**DEPARTMENT OF TRANSPORTATION**

**Federal Aviation Administration**

**14 CFR Part 36**

**Noise Certification Regulations for Helicopters**

**Figure H1.**  
**Comparison of Measured and Reference Takeoff Profiles**

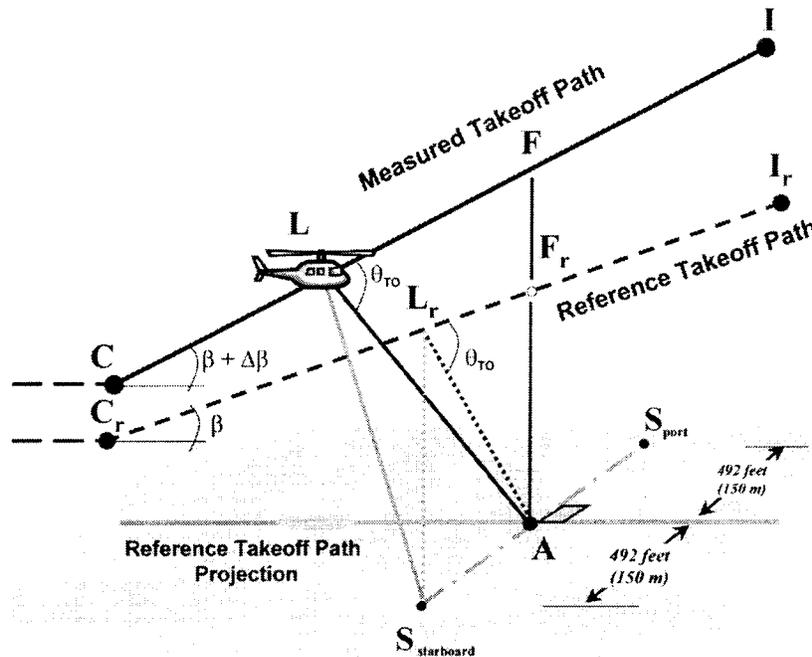
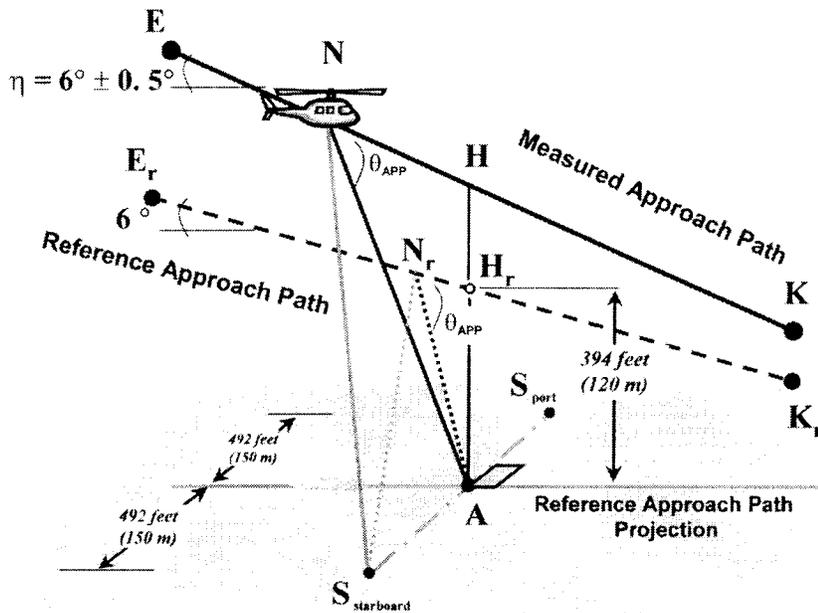
In Notice No. 00-12, the FAA proposed to revise Figures H1 and H3 to include the height above measurement points in metric units and to delete the closest point of approach (CPA) distance designations. The FAA received no comments on this proposal and it is being adopted as proposed.

Figure H2.  
Comparison of Measured and Reference Flyover Profiles

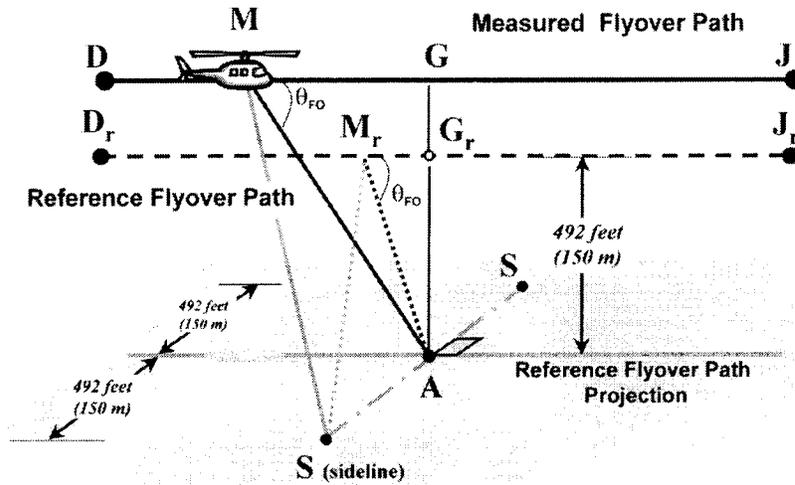
Although Figure H2 changes were not addressed in the NPRM, for accuracy and completeness, the FAA is making corrections to typographical errors and replacing incomplete designations. The word “corrected” is replaced with the word “reference” in the titles of Figures H1, H2 and H3 in the final rule. This change keeps the language in the final rule consistent throughout Appendix H.
